HISTORIC AND DESIGN REVIEW COMMISSION

HDRC CASE NO: 2020-416
ADDRESS: 514 W QUINCY
LEGAL DESCRIPTION: NCB 16821 BLK 1 LOT 3 (SAISD CENTRAL OFFICE)
ZONING: D,RIO-7A
CITY COUNCIL DIST.: 1
APPLICANT: Liz Hurd/RVK Architects
OWNER: Kamal ElHabr/SAN ANTONIO ISD
TYPE OF WORK: Construction of a multi-story parking garage, signage
APPLICATION RECEIVED: September 18, 2020
60-DAY REVIEW: Not applicable due to City Council Emergency Orders
CASE MANAGER: Stephanie Phillips

Re: Bexar County – Quincy Street Parking Garage
HDRC Case No. 2020-416 - Response

ENTRANCE OFF QUINCY STREET

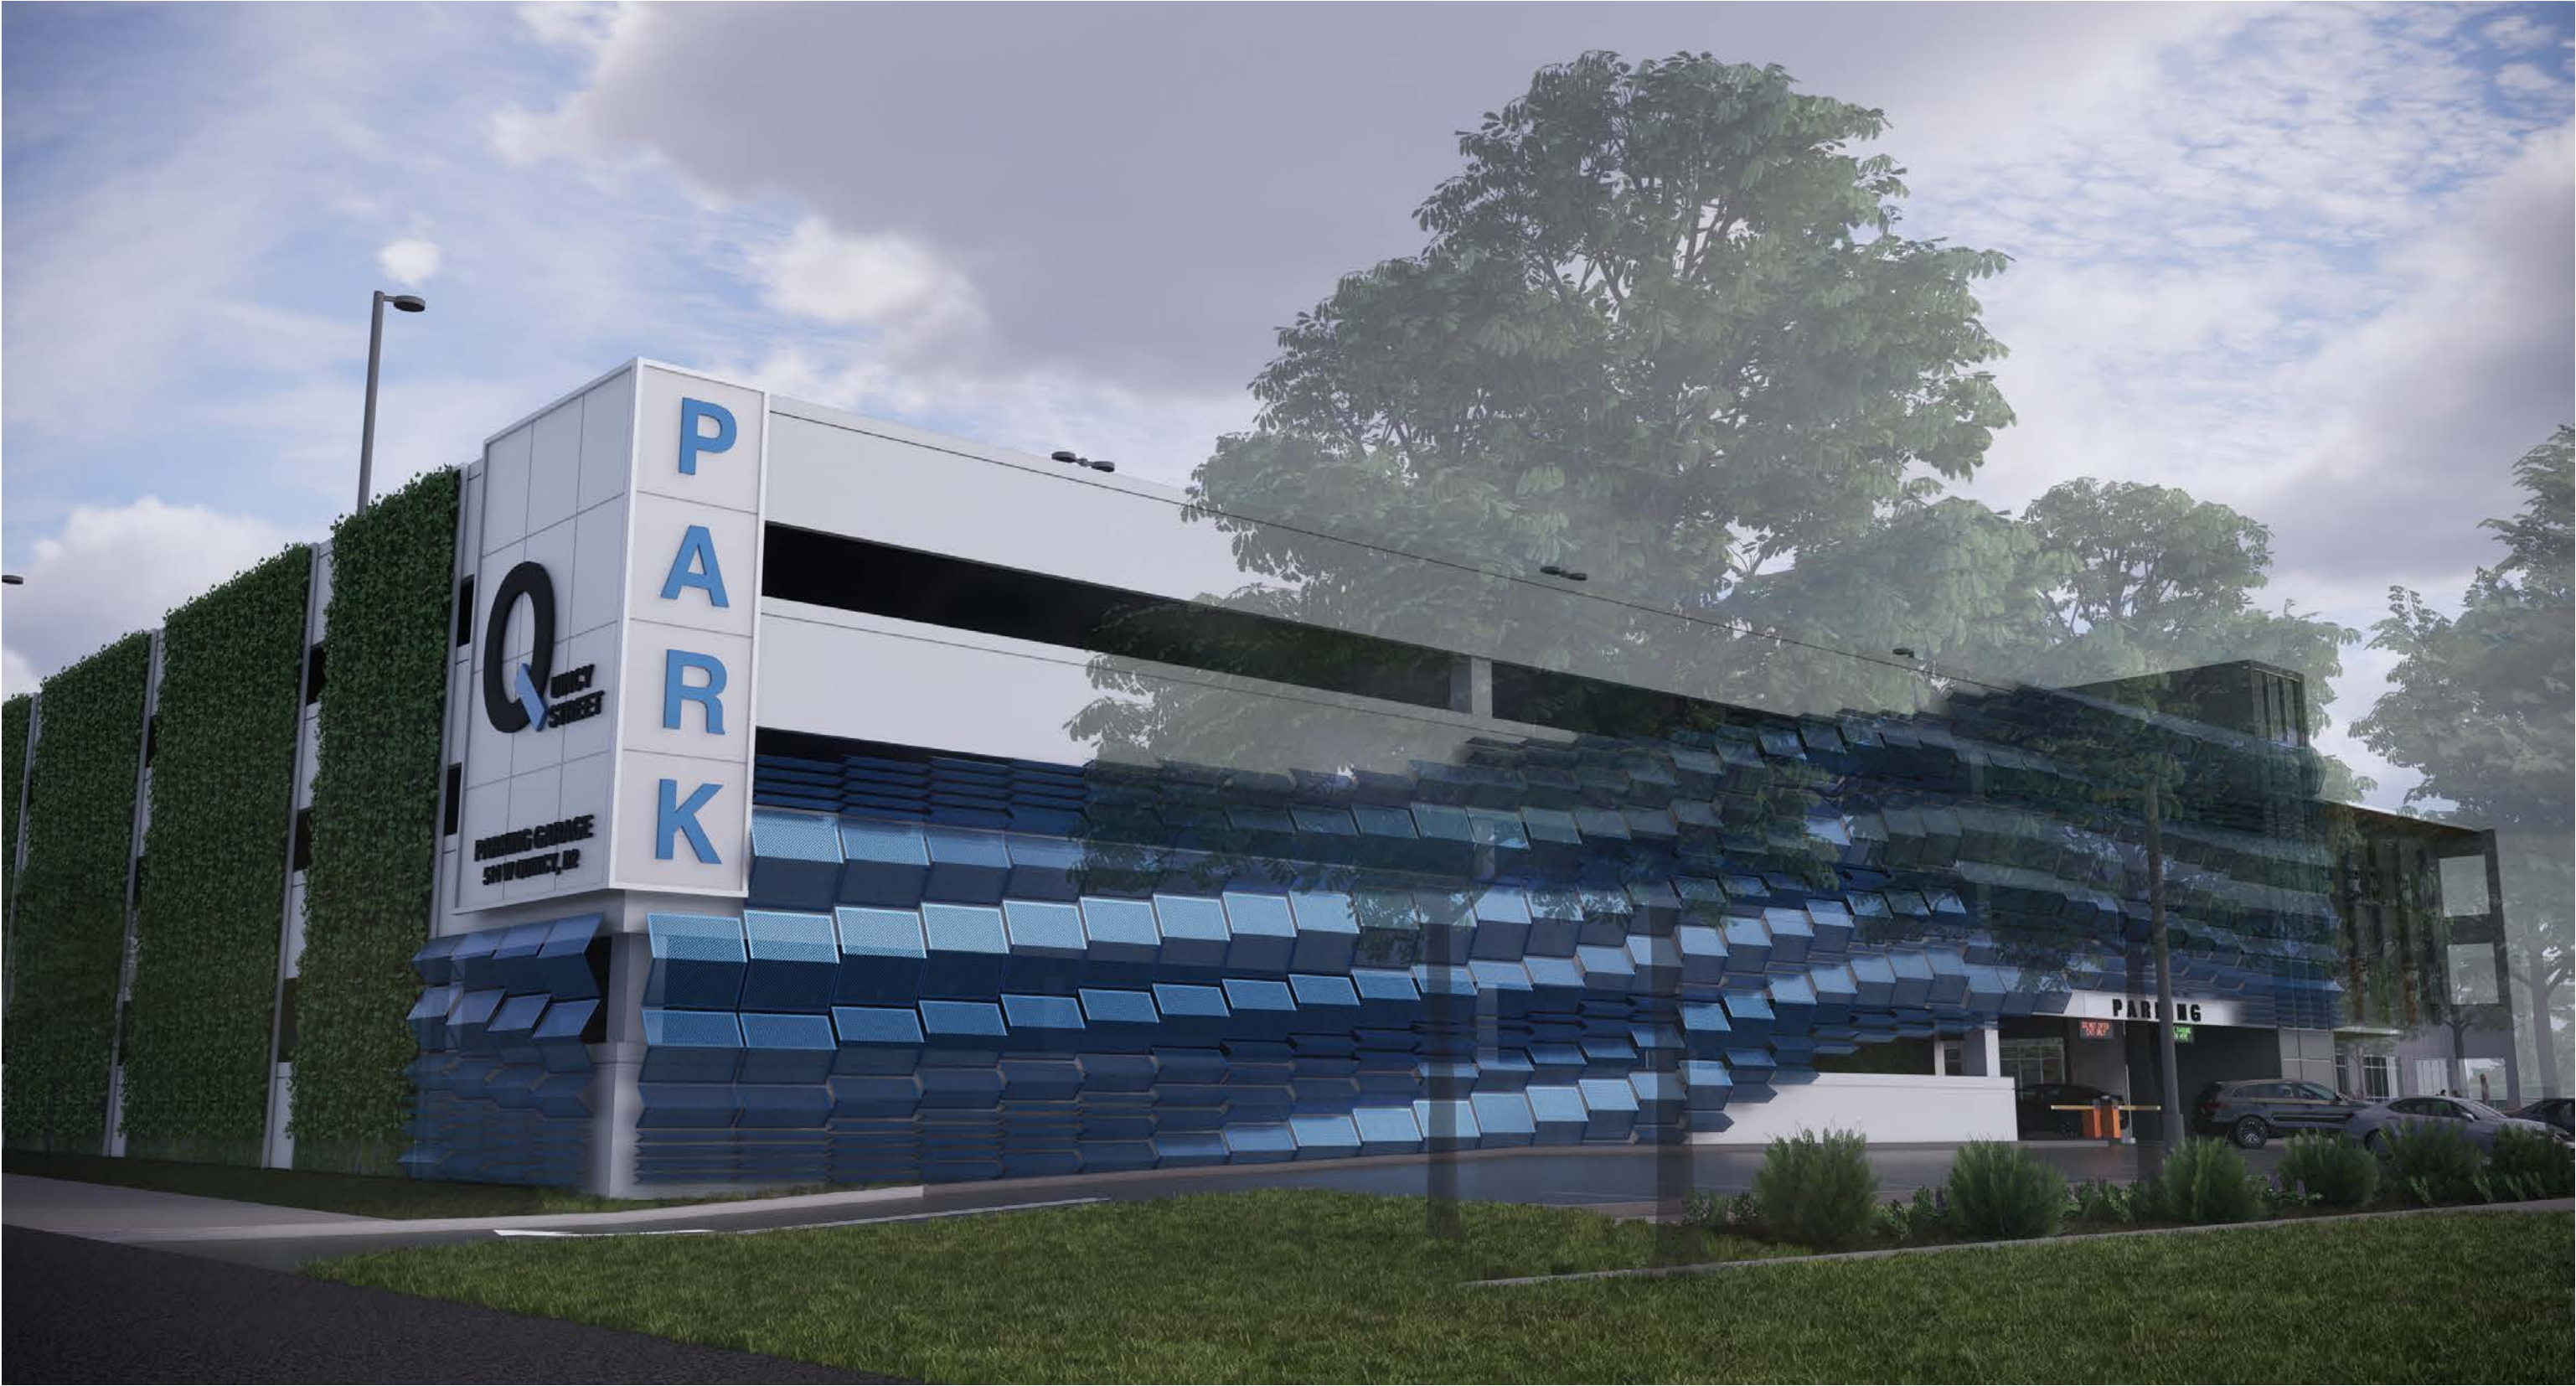
- d. **PEDESTRIAN ACCESS** – The standards for RIO-7A state that building entries should be designed to be clearly visible from the street or creek, as well as to promote pedestrian comfort, safety, orientation and accessibility. A building's entry should be reinforced with one or more of the following architectural treatments: i. Extra height lobby space; ii. Distinctive doorways; iii. Decorative lighting; iv. Distinctive entry canopy; v. Projected or deep recessed entry; vi. Building name and address integrated into the facade; vii. Artwork integrated into the facade or sidewalk; viii. A change in paving material, texture, or color within the property line; ix. Distinctive landscaping, including plants, water features and seating. The primary street entrance of single buildings will be off the public sidewalk. As currently proposed, primary pedestrian access to the parking garage is from an internal location on the site, facing the administration building. There is also a defined pedestrian entrance from W Quincy, with a winding pedestrian entrance that accesses S Flores St. Proposed designs facing San Pedro Creek should clearly feature a defined pedestrian access point that complies with RIO-7A standards, including but not limited to: a distinctive entry canopy, extra height space, artwork integrated into the façade or sidewalk, or projected or deep recessed entry; or reconfiguring the access point into the currently proposed tower element. The applicant has proposed projecting canopies from pedestrian access points and clearly defined pedestrian walkways from major streets and San Pedro Creek. Staff finds that this meets the UDC.

RESPONSE: i. The RIO-7A states "the building entries should be designed to be clearly visible from the street or creek, as well as to promote pedestrian comfort, safety, orientation and accessibility" The design team, County and the District focused especially on the comfort, safety, and accessible portion of that statement. Pedestrians can access the parking garage from N. Flores, Quincy, Camaron, and Kingsbury through a series of accessible walkways internal to site. The main primary entrances were designed to have controlled access from the internal walkways between the parking garage and the Central Office Building. This internal access was determined due to the following reasons: San Pedro Creek pedestrian access is Southwest of the parking structure; at the base of the parking structure one overlooks/ transitions between the green space and amphitheater onto San Pedro Creek. There are multiple ADA pathways that can lead one down to the creek. The parking garage is located on the site where the structure is 1'-0" away from the easement along Quincy, the elevated highway and multilane major traffic at Quincy and N. Flores, along with the site sloping from east to west there is not a natural entry into the garage. This internal access creates a wide plaza for the pedestrians to gain access to the parking garage, San Pedro Creek or the Central Office Building. There is accessible pedestrian access through the green space from Quincy and N. Flores. See updated attachments illustrating pedestrian site circulation.

1 FLOOR PLAN
SITE PLAN
1" = 20'-0"

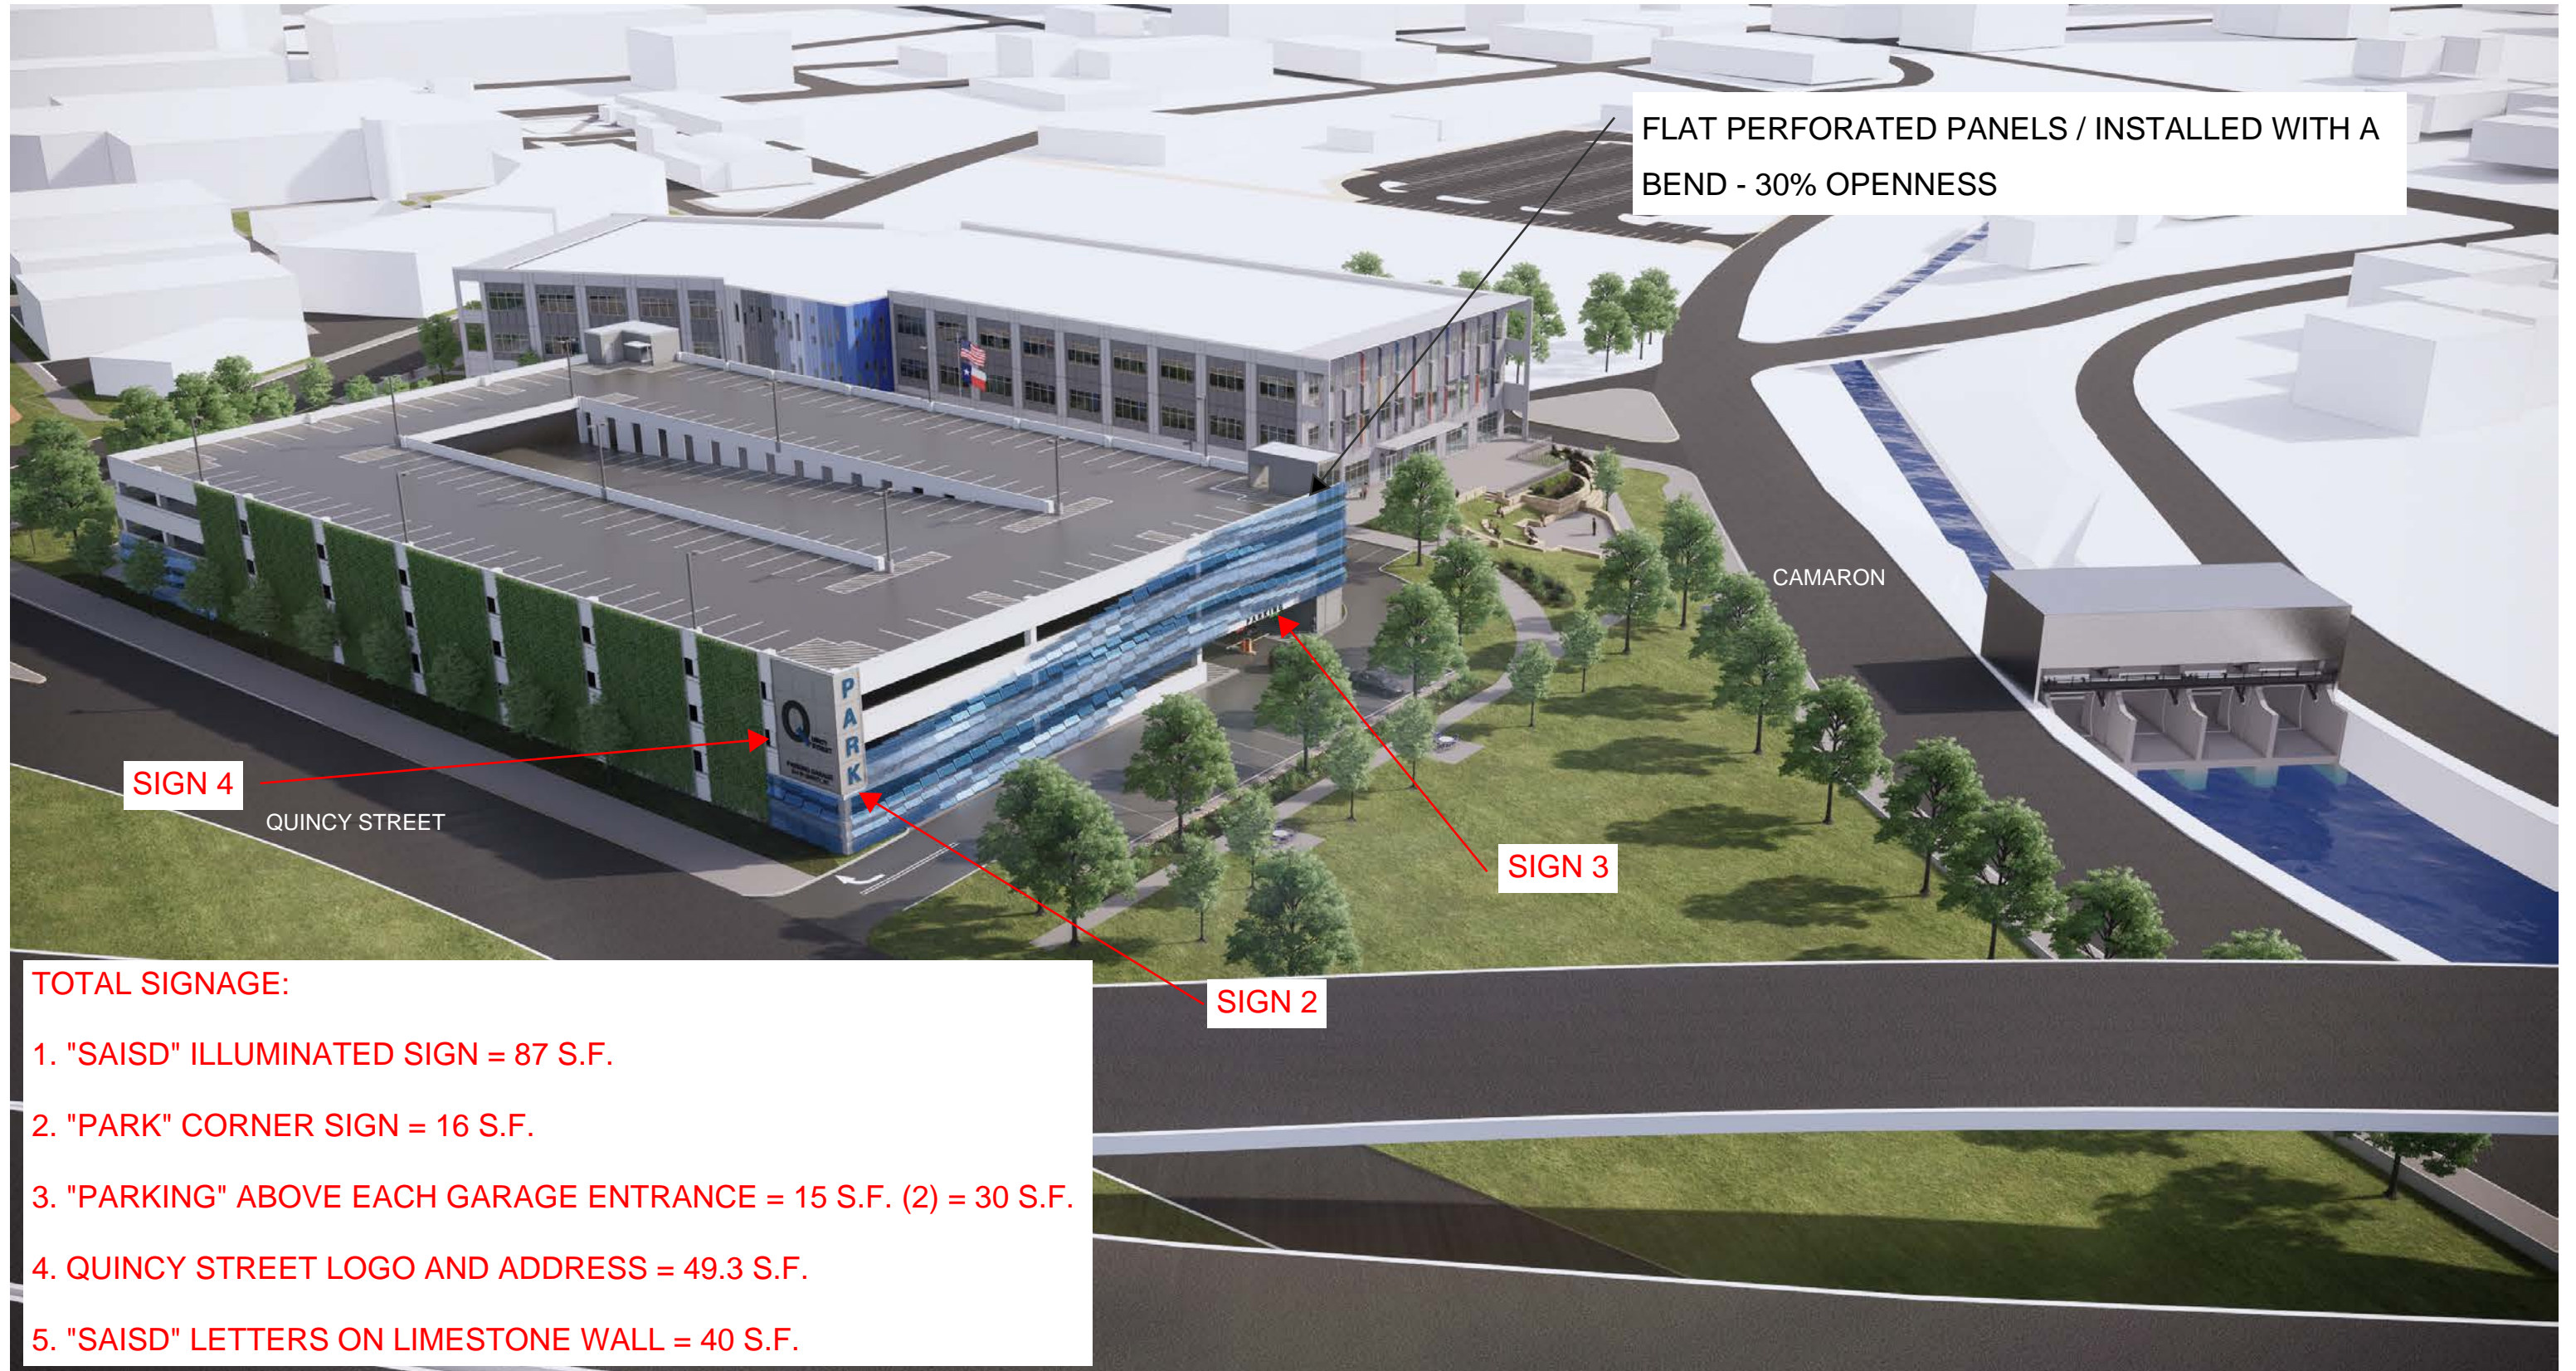
- i. That the applicant reduces the height of the N. Flores SAISD sign to a maximum of 3'-0" to be more consistent with the UDC, and to align with the previous HDRC approval form 2019.
- ii. The applicant reduces the overall signage for the site, including building signage and monument signage for both structures, be limited to no more than 3 signs and a maximum of 50 square feet to comply with RIO standards for signage.

RESPONSE: i. The design team reduced the height of the N. Flores SAISD sign to 3'-0" as recommended. ii. The design team reduced the amount of signage as recommended by the HDRC commissioners during the preliminary design review meeting. The attached renderings indicate the location of the signage. As discussed by the HDRC Commissioners, the signage is secondary to the overall design of the parking garage enhancements. The signage height and width are in proportion to the entire façade. There are three building / monument signs – one building sign on the corner of the garage at the Quincy street entrance, one monument sign on the green screen wall at the N. Flores entrance, and one pedestrian sign at the entry at Kingsbury.
